Grounding Cable Assembly

| .54 FT | 3 | 601.2695 | ELEC | 84529765 | 125-14 | 1 | | | |
|---------------|--|---|---------------|---|----------|-------|---|--|--|
| | | CONTRACT No. | 7 | GROUN | DING CAE | BLE A | \SSY | | |

Subject: 648.7801

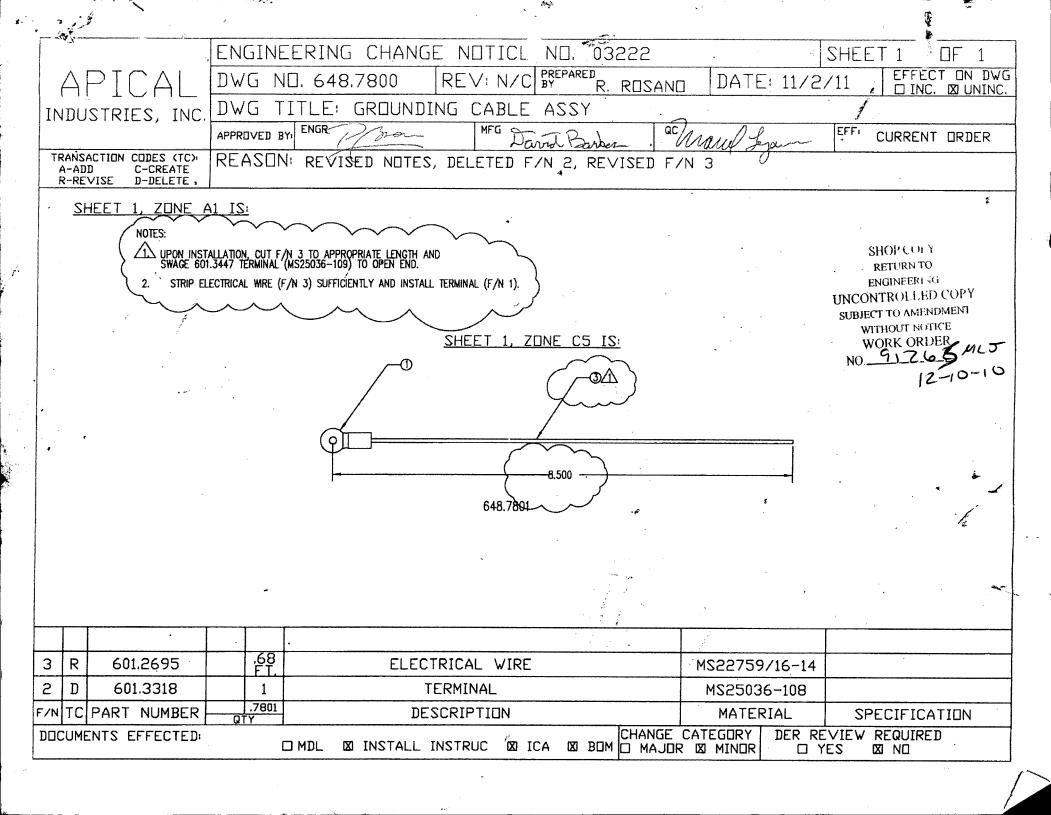
We are about to assemble the 648.7801 grd cables and the wire called up is MS22759-16-14, but the wire we received is MS22759-16-14-9, is this the same pls??

MS22759/16-14 is the general Tefzel 14 AWG wire callout.

MS22759/16-14-9 should be the 14 AWG wire with a white jacket. So it's the same wire. If you have any other questions let any of us know!
